TECHNICAL BULLETIN

Engine Oil – Viscosity/Temperature Ranges – Revisions

MODEL 1995-96 MY
Sedan Range
VIN
720001-ON

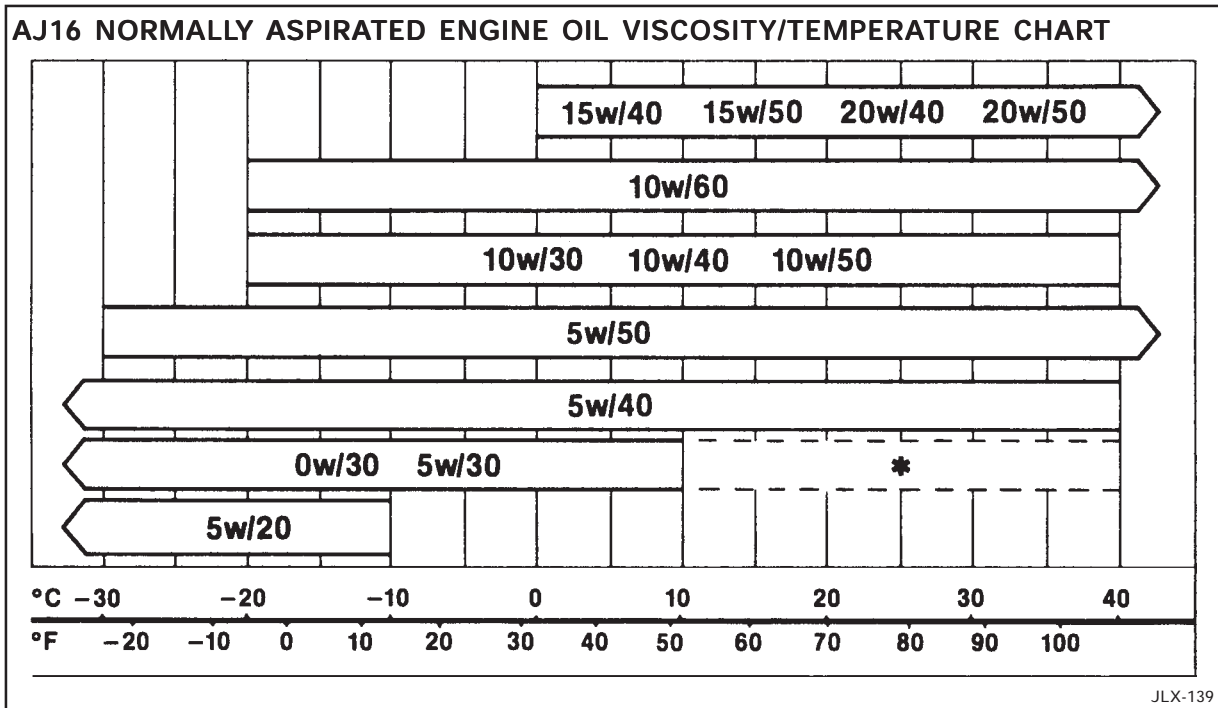
In addition, the ambient temperature range for the use of 5W/30 oils has been extended from 50°F (10°C) to 104°F (40°C) subject to certain limitations on oil specifications on AJ16 normally aspirated engines ONLY.

*** NOTE:** The use of 0W/30 and 5W/30 oils is allowed during ambient temperatures of 50-104°F (10-40°C) ONLY if:

- the oil is purely synthetic
- the oil meets API SH/CF and CCMC G5 specifications.

V12 & AJ16 SUPERCHARGED ENGINE OIL VISCOSITY/TEMPERATURE CHART

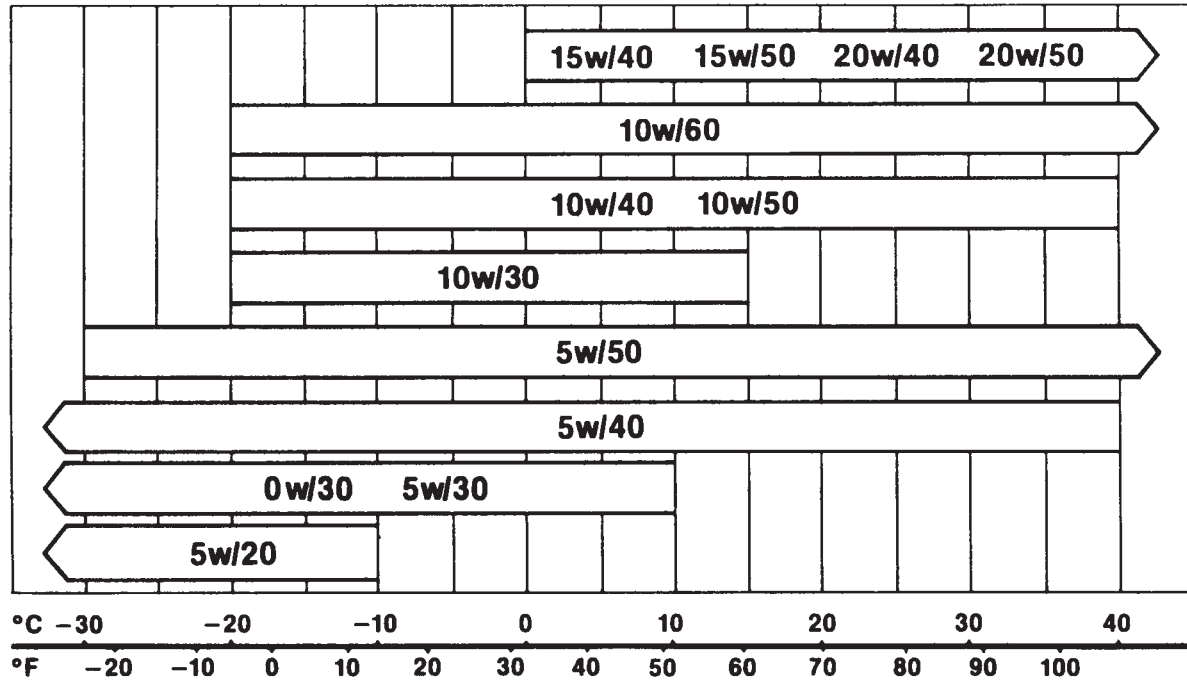
Jaguar has approved the use of grade 0W/30 low viscosity engine oils, subject to certain limitations regarding ambient temperature and oil specifications, in both V12 and AJ16 engines.
